Thank you for your letter and for the reviewers' comments concerning our manuscript entitled "Characteristics and RISM of sliding flow landslides triggered by prolonged heavy rainfall in the loess area of Tianshui, China" (ID: nness-2022-135). Those comments are all valuable and very helpful for revising and improving our paper, as well as the important guiding significance to our researches. We have studied comments carefully and have made correction which we hope meet with approval. The authors upload the both file ([one is revised with tracking word and the other is revised without tracking word](#)). The main corrections in the paper and the responds to the reviewer's comments are as following:

Responds to the reviewer's comments:

Fig. 1 The distribution of the “7.25” Tianshui sliding-flow landslides vs slope

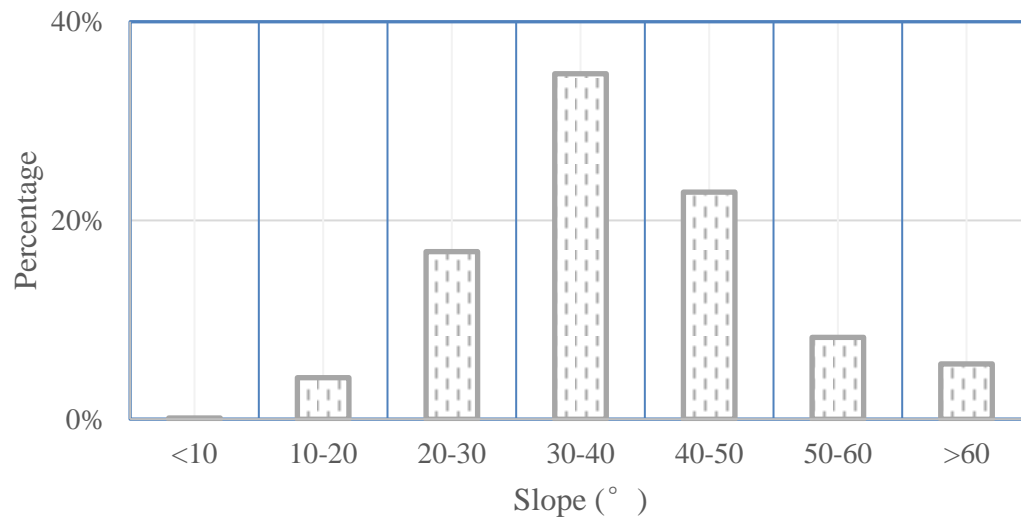
- the study is focused on the development of RISM model, for a better estimation of safety factor for slope higher than 50° . However, as seen from field data (in figure 7), all landslides are triggered in slopes lower than 35° . In that way, we do not really understand why the development of this model can help in quantifying the stability of slope in this context.

P12 line 214 : it is mentioned that “loess landslide transformation to mudflows occur most often on slopes of 25 – 45°” ; why is it different from the results shown on figure 7? Please explain.

Responded: Thank you very much. This is a particularly good suggestion. It is difficult to reach the landslide location when the slope greater than 35° and conduct field measurements during the field investigations. So, the 89 landslides measured in the field investigation were within the range of 35° . However, it can be seen from the figure 1 that the "7.25" Tianshui sliding-flow landslides is mainly distribution between $20-50^\circ$, and more than 50% of the sliding-flow landslides are located in slope with greater than 35° according to all the "7.25" Tianshui sliding-flow landslides data. the main purpose of this manuscript is to improve the deficiency that the safety factor invariable or increases with the slope increasing when the slope is larger than 40° calculated using the Taylor slope infinite model using equal

Responded: Thank you very much. It is difficult to reach the landslide location when the slope greater than 35° and conduct field measurements during the field investigations. So, the 89 landslides measured in the field investigation were within the range of 35°. However, it can be seen from the figure 1 that the “7.25” Tianshui sliding-flow landslides is mainly distribution between 20-50°, and more than 50% of the sliding-flow landslides are located in slope with greater than 35° according to all the “7.25” Tianshui sliding-flow landslides data.
